OULTON PARISH COUNCIL: PINS Ref: 20022619

Re: NORFOLK BOREAS: Oulton Parish Council's submission at Deadline 2

Oulton Parish Council's response to Written Questions for Norfolk Boreas Scenarios 1 & 2 at Deadline 2

Hornsea Project Three

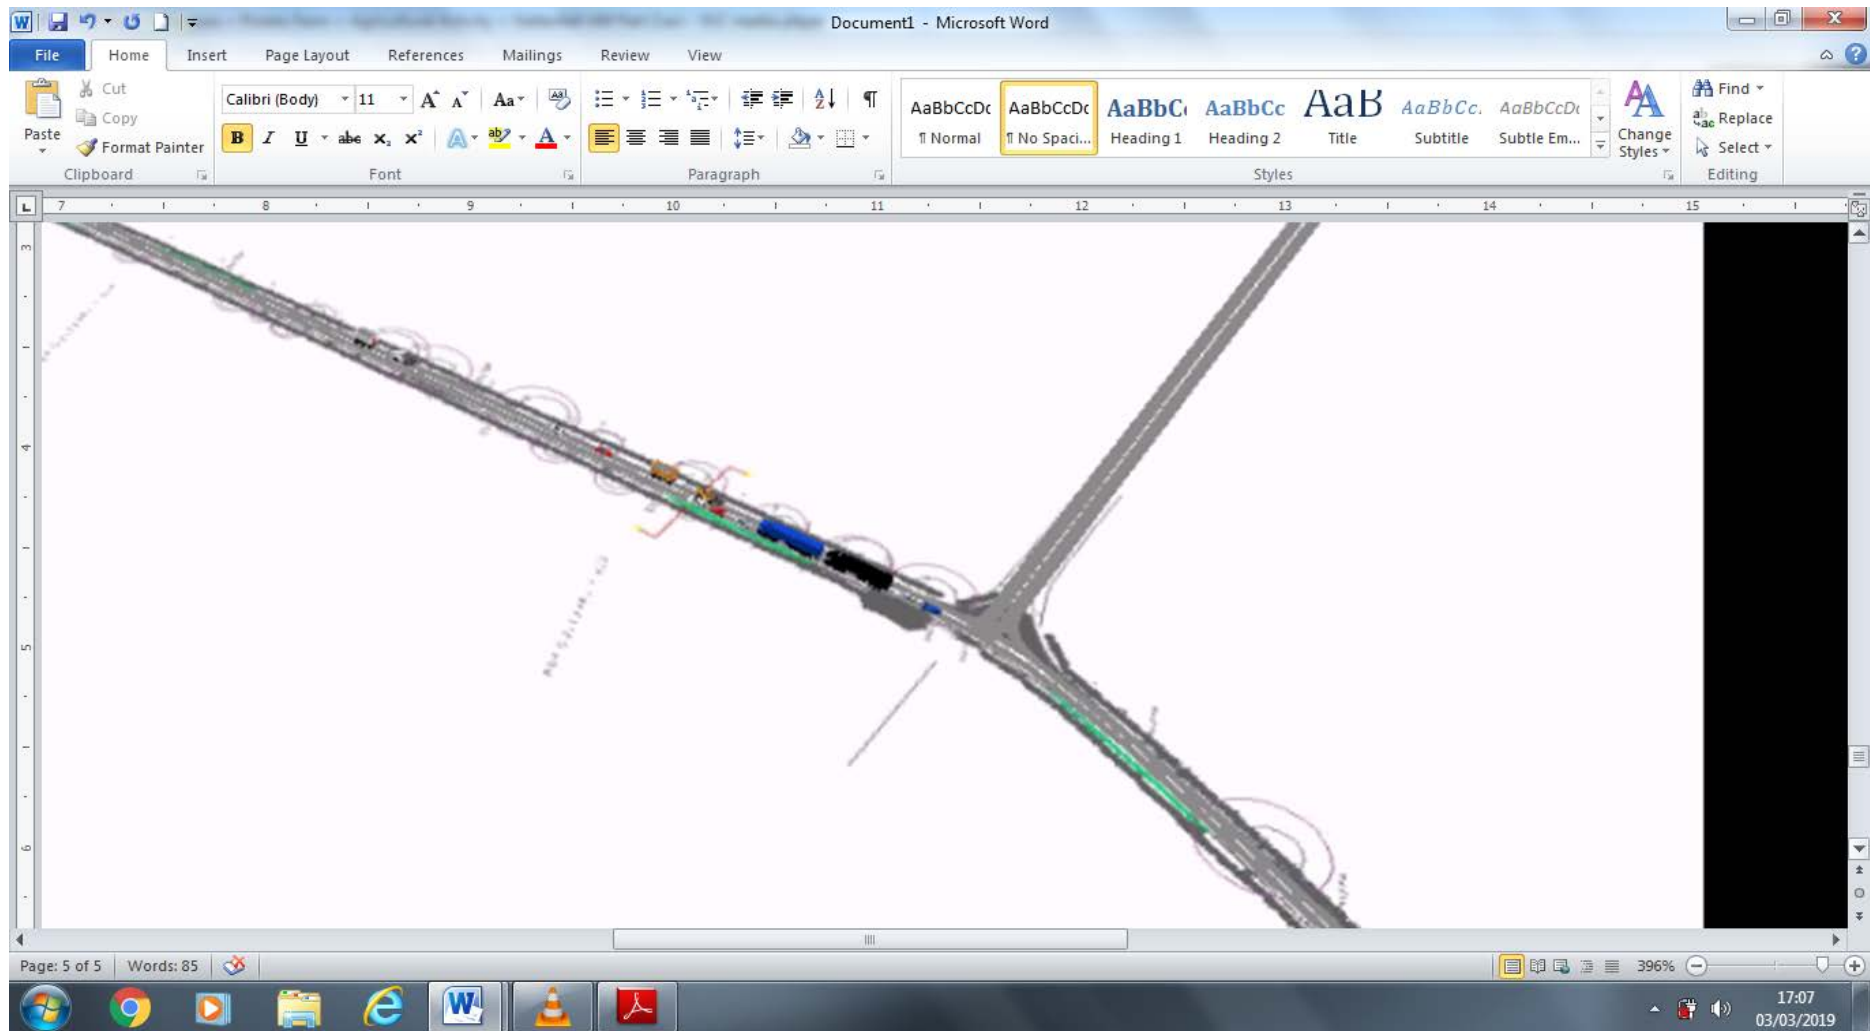
(ABOVE) Two tractors outside old railway gatehouse, potential for vehicles to overrun side of road and, in any case, the road width proposed makes such a passing impossible.

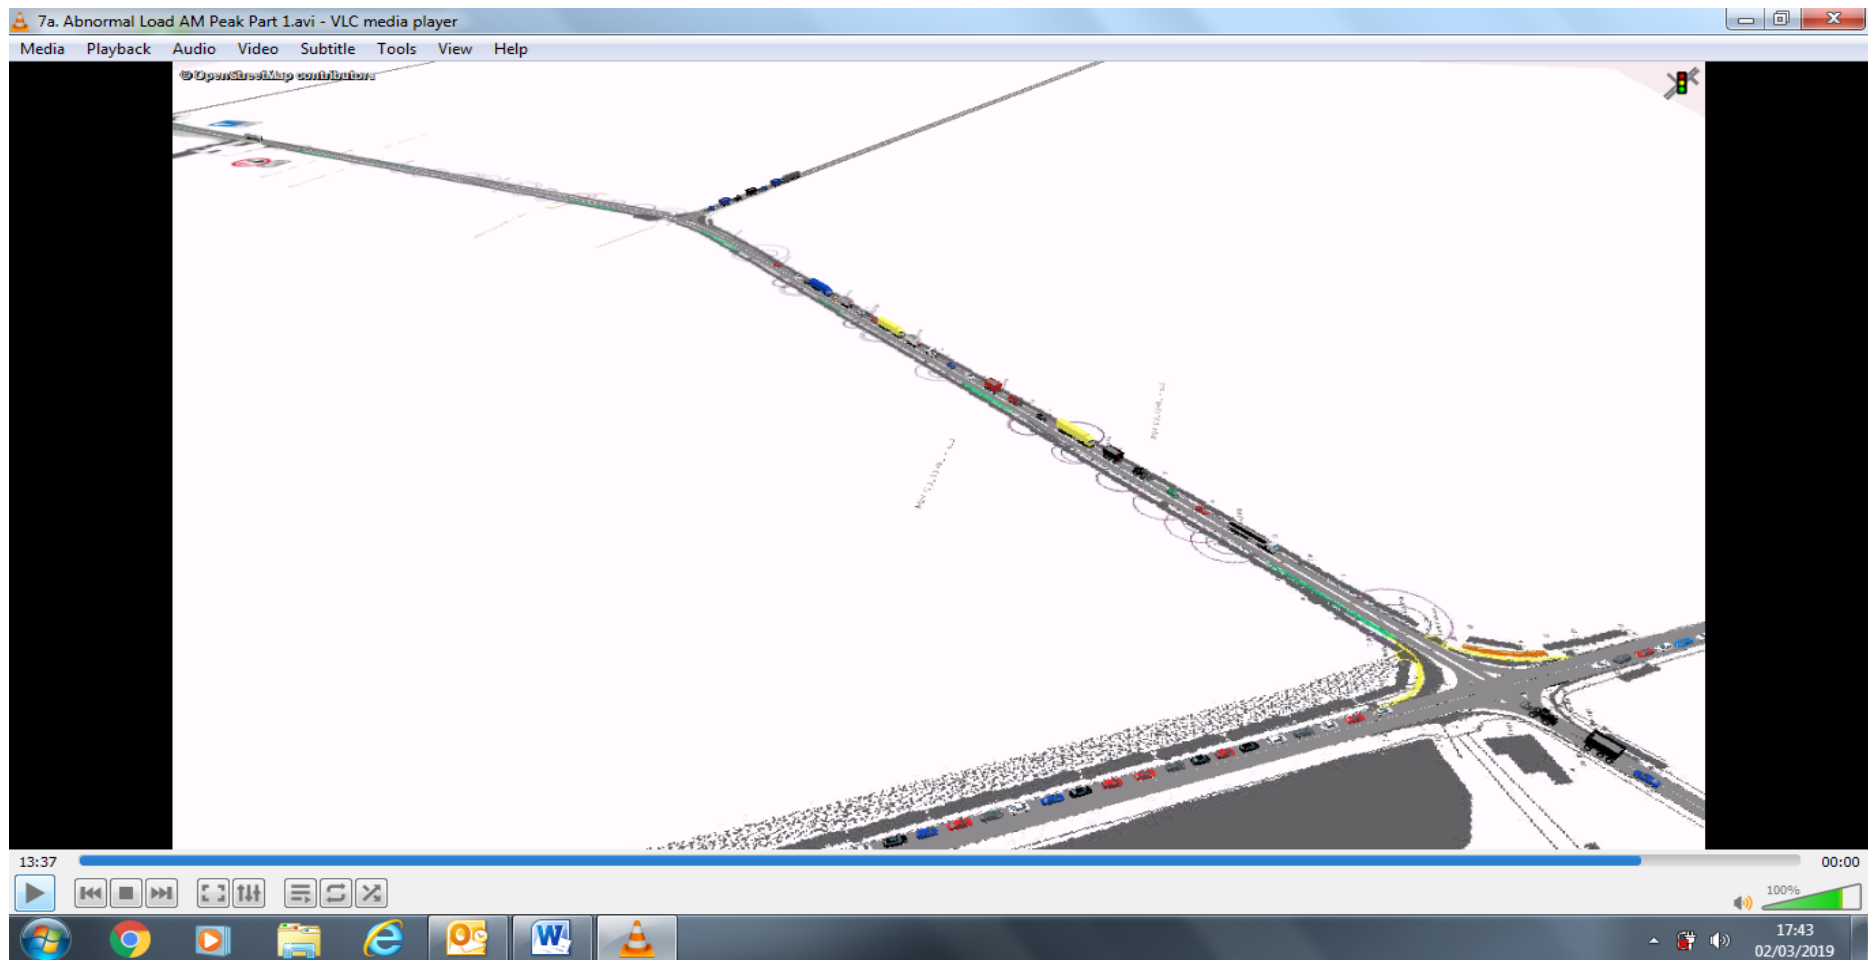
(Above) Enlarged view of bend. [6b 2028 Base + Hornsea + Potato Farm + Agricultural activity + Vattenfall AM part 2]...shows 2 cars 1 HGV in passing place 1 HGV & 2 Cars outside of passing place at bend, waiting for oncoming traffic.(3.33sec)
